**MONTGOMERY COUNTY HISTORIC PRESERVATION COMMISSION**  
**STAFF REPORT**

<b>Address:</b>	102 East Kirke Street, Chevy Chase	<b>Meeting Date:</b>	9/4/2024
<b>Resource:</b>	Outstanding Resource <b>Chevy Chase Village Historic District</b>	<b>Report Date:</b>	8/28/2024
<b>Applicant:</b>	Britt & Will Williams (Luke Olson, Architect)	<b>Public Notice:</b>	8/21/2024
<b>Review:</b>	HAWP	<b>Tax Credit:</b>	n/a
<b>Permit No.:</b>	1067931 REVISION	<b>Staff:</b>	Dan Bruechert
<b>Proposal:</b>	Fenestration Alteration to Previously Approved HAWP

Figure 3: Approve HAWP (left) and revised design (right).

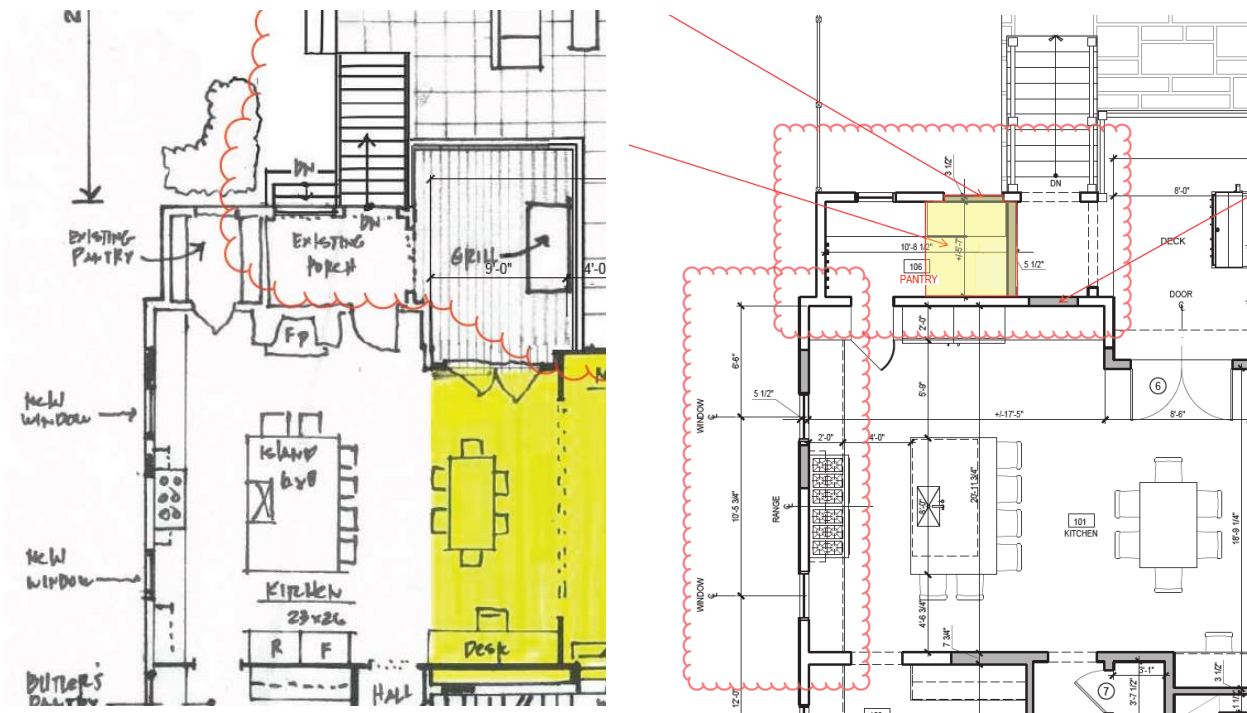
At the rear of the east wing of the subject property, there is a two-story projection. The 1927 Sanborn map shows this feature as an enclosed porch. On the first floor, there are three arches that create a covered porch with access to the rear of the house (see *Figure 2*, below). The approved HAWP proposed no changes to this space. The applicant now proposes to block in one of these arches, creating a blank arch, and eliminate the rear door that provided direct access to the kitchen. The interior space created will allow for a larger pantry.

Staff finds the current appearance of the rear elevation is not historic and developed after the sleeping porch was captured as interior space. Staff further finds the existing full-light wood door is not historic fabric. There is no guideline that relates directly to the type of work proposed; however, Staff finds that two of the five basic policies guiding decisions in the Chevy Chase Village Historic District provide some direction.

of-way, Staff finds the proposal is generally in keeping with the spirit of the *Design Guidelines*. Additionally, Staff finds the proposed changes at the rear are consistent with 24A-8(b)(2) and (d) and Standards 2, 9, and 10 and recommends the HPC approve the arch revision and door removal.

**1 FIRST FLOOR PLAN**  
SCALE: 1/4"=1'-0"

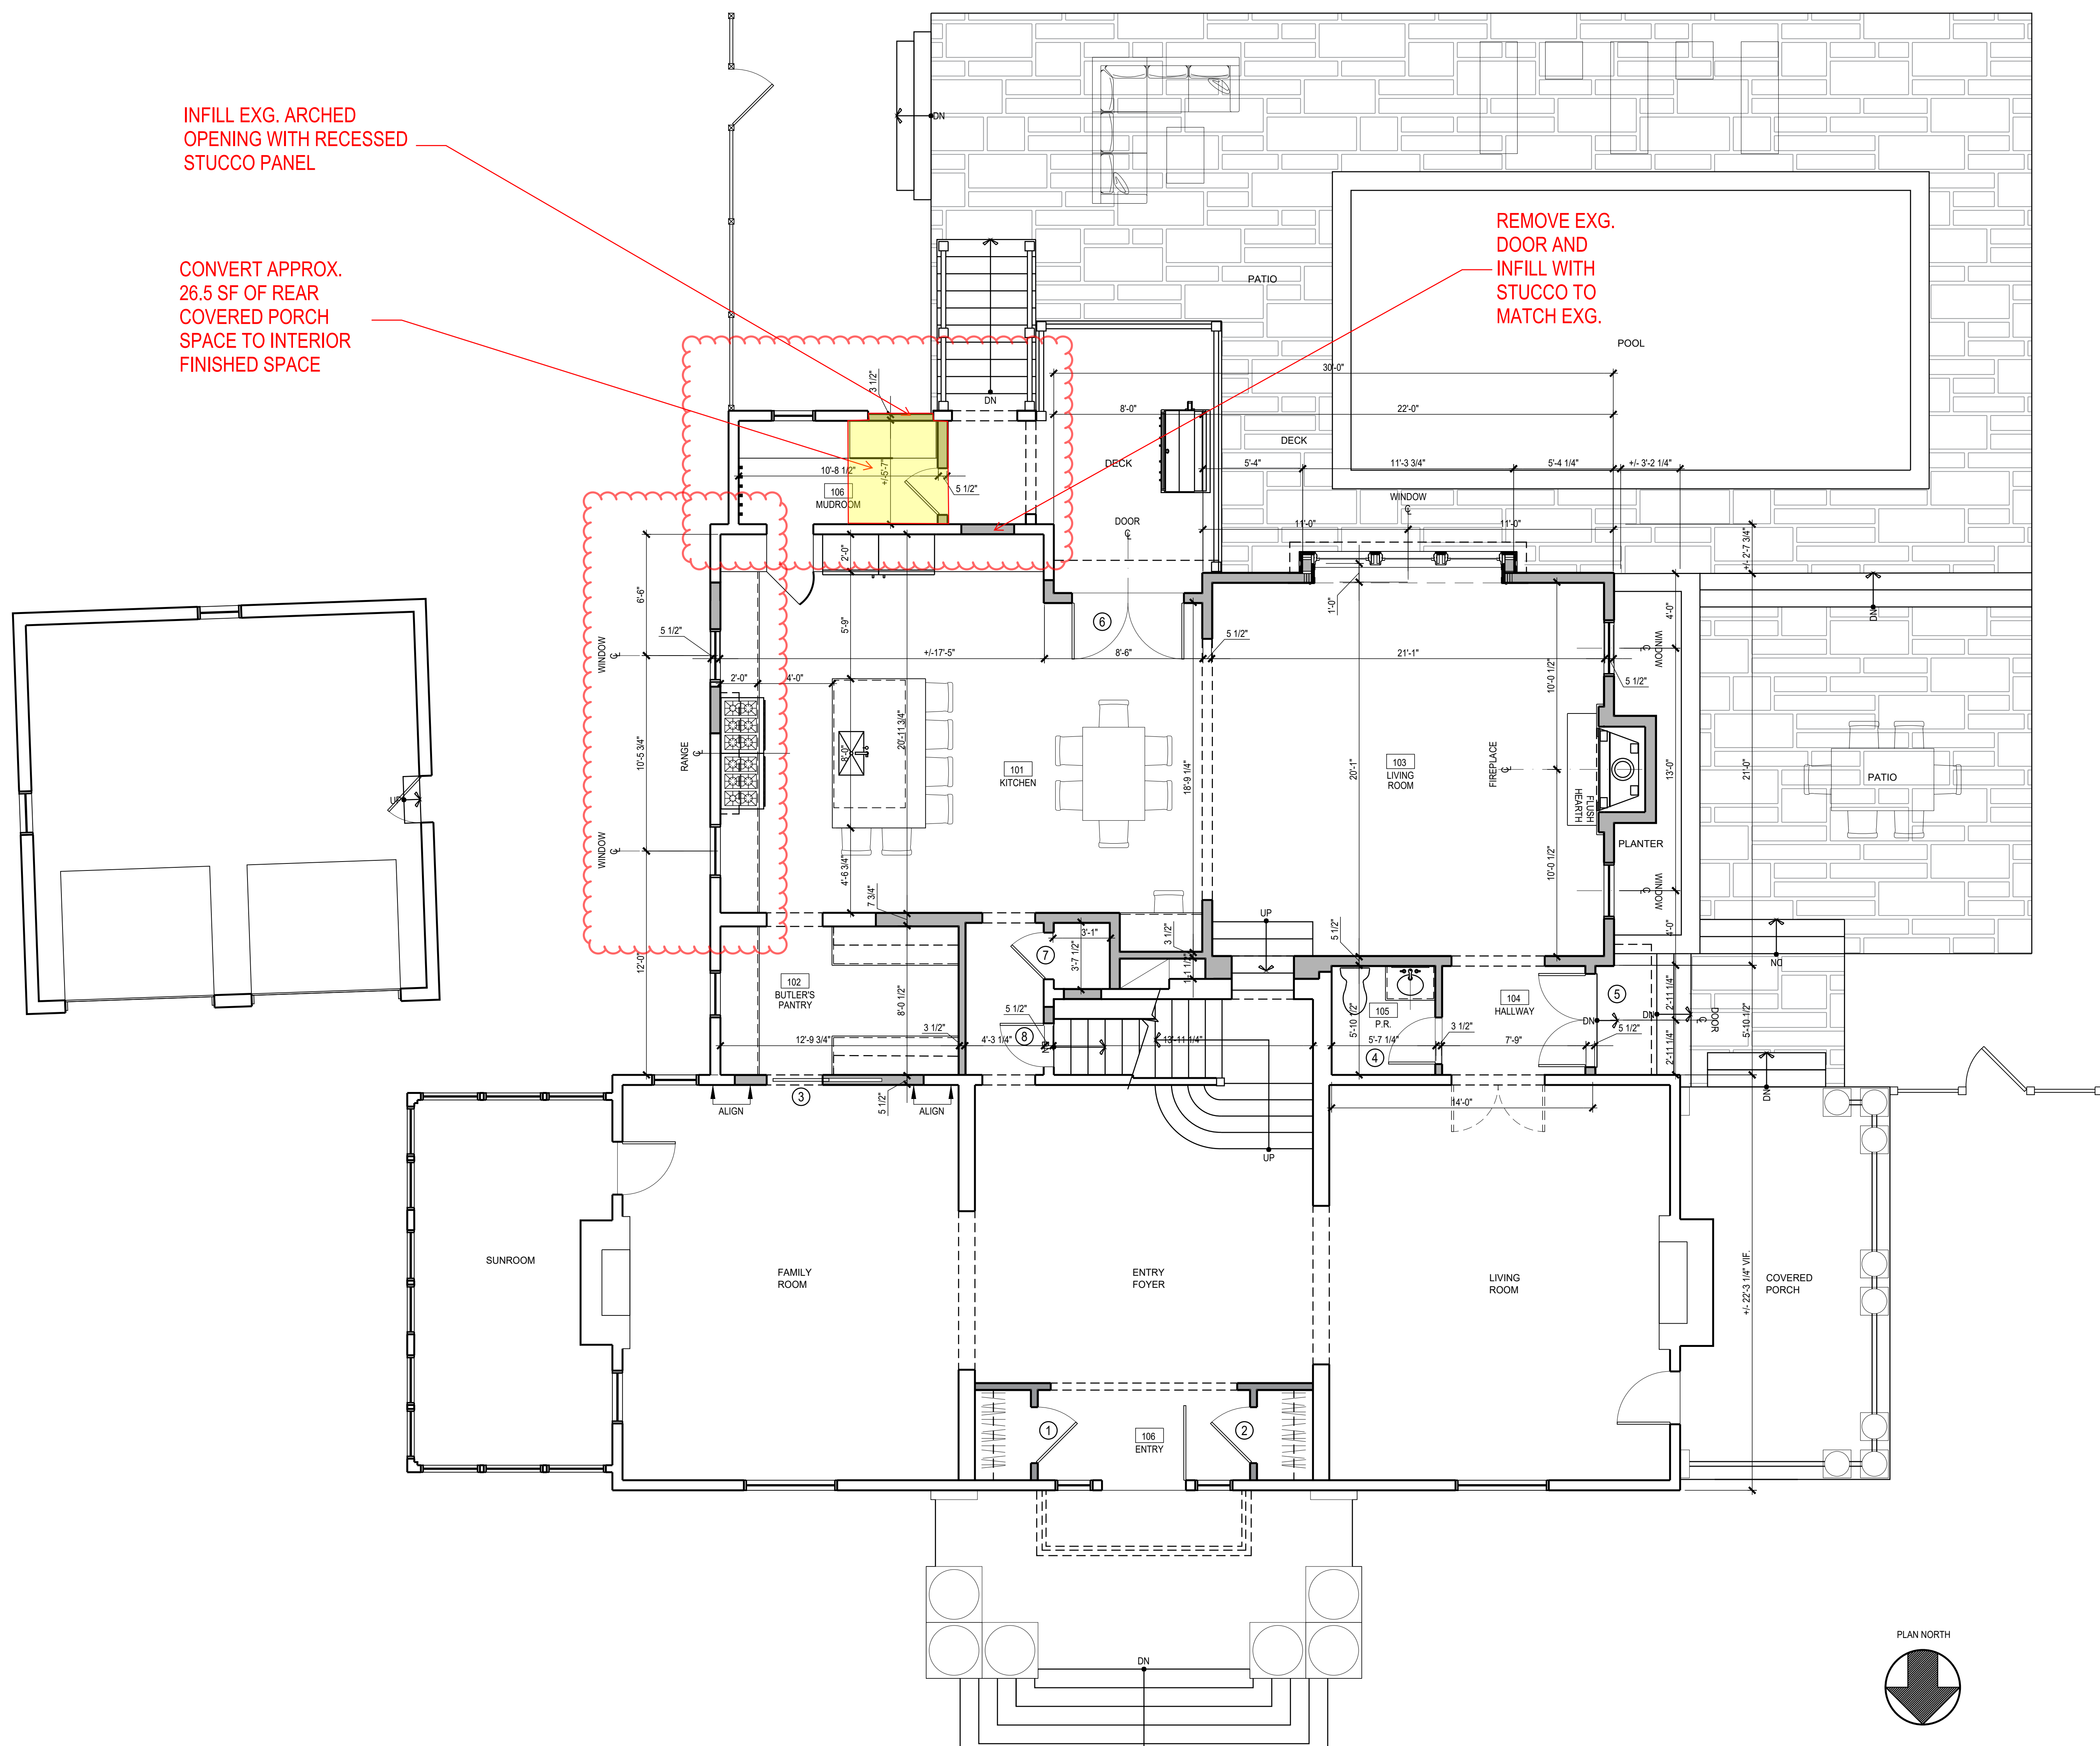
INFILL EXG. ARCHED  
OPENING WITH RECESSED  
STUCCO PANEL

CONVERT APPROX.  
26.5 SF OF REAR  
COVERED PORCH  
SPACE TO INTERIOR  
FINISHED SPACE

REMOVE EXG.  
DOOR AND  
INFILL WITH  
STUCCO TO  
MATCH EXG.

Sheet No.  
**A202**

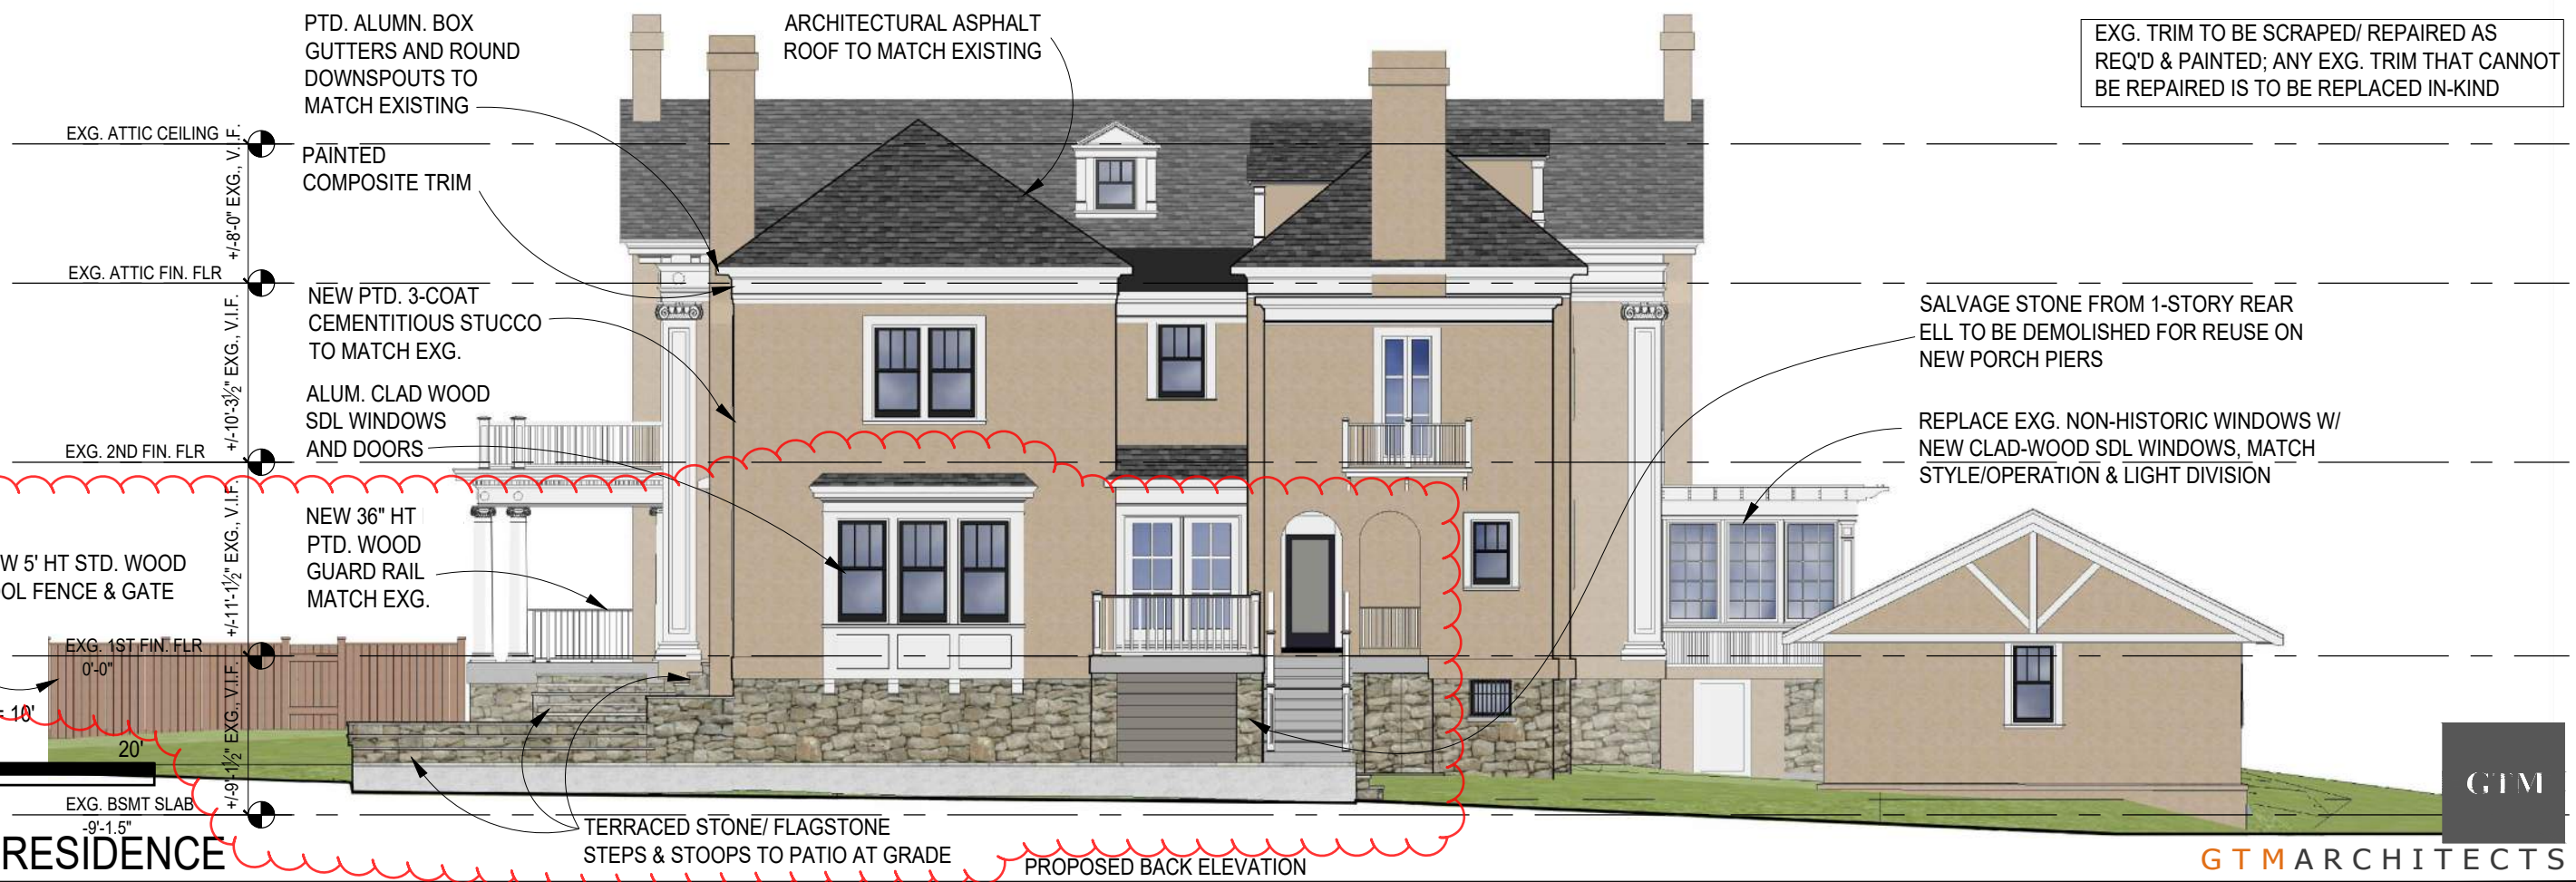
NEW DOOR IN  
COVERED PORCH  
SPACE TO BE  
CONVERTED TO  
FINISHED SPACE
